Staff Report

To: Salt Lake City Historic Landmark Commission
From: Lex Traughber – Senior Planner
(801) 535-6184 or lex.traughber@slcgov.com
Date: September 3, 2015
Re: Petition PLNHLC2015-00360, Marmalade Townhomes

NEW CONSTRUCTION IN AN HISTORIC DISTRICT

PROPERTY ADDRESS: 535 N. Arctic Court

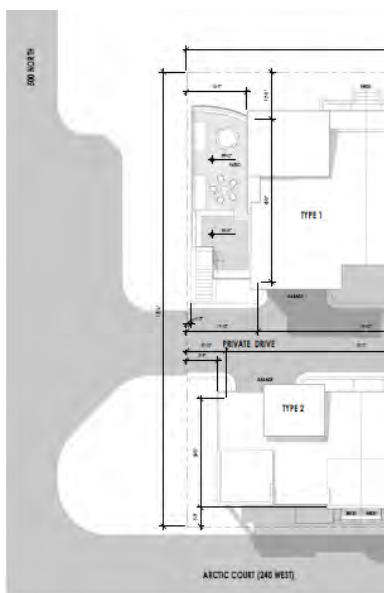
As part of the proposal, the applicant is requesting that the HLC modify the required front and rear yard setbacks; a reduction of the setbacks for both yards as shown on the proposed site plan. Please refer to site plan for setback details (Attachment C). **Specifically, the applicant is requesting that the HLC approve the applicant’s site plan as proposed.**

The applicant is requesting that the front yard setback along 500 North for the Type 1 units be essentially eliminated, however the patio that is proposed for these units in the front yard along 500 North provides almost 17 feet between the property line and the front façade of the building. In essence, the building itself meets the required 15 foot setback. The Type 2 units are setback approximately 11 feet from 500 North, so the applicant is requesting a reduction of 4 feet. This area will be landscaped.

The rear yard setback for both the Type 1 and Type II units is proposed to be significantly reduced, however it should be noted that these buildings abut a high density multifamily development to the north, separated by an access drive. The required rear yard setback is 25 feet in the RMU Zone. The applicant is proposing approximately a 16 foot setback for the Type 1 units and a 9 foot setback for the Type 2 units.
